Addendum 12: Regulation No. 13

Revision 4 - Amendment 1

Supplement 5 to the 09 series of amendments - Date of entry into force: 27 December 2000

UNIFORM PROVISIONS CONCERNING THE APPROVAL OF VEHICLES
OF CATEGORIES M, N AND O WITH REGARD TO BRAKING

"3. Example of a simulator for electric control lines

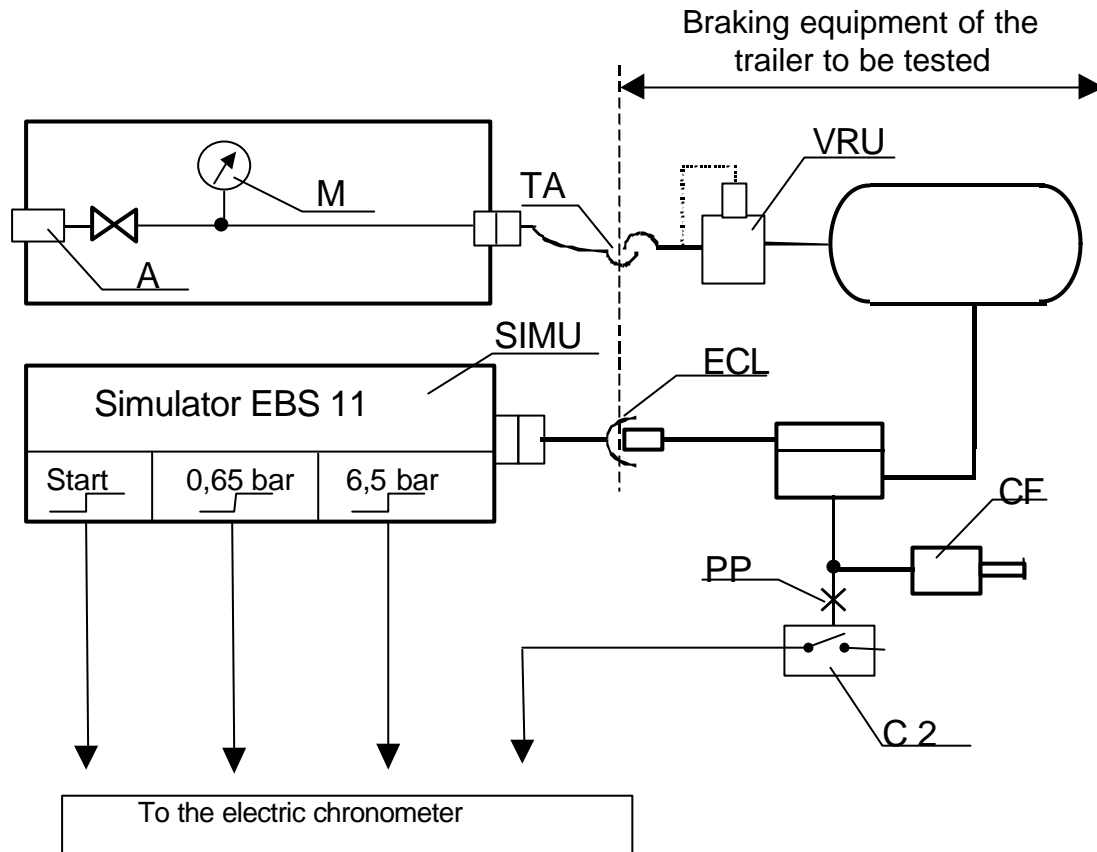
Annex 6, appendix, insert a new figure 3., to read:

ECL = electric control line corresponding to ISO 7638

SIMU = simulator of Byte 3,4 of EBS 11 according to ISO 11992 with output signals at start, 0.65 bar and 6.5 bar."
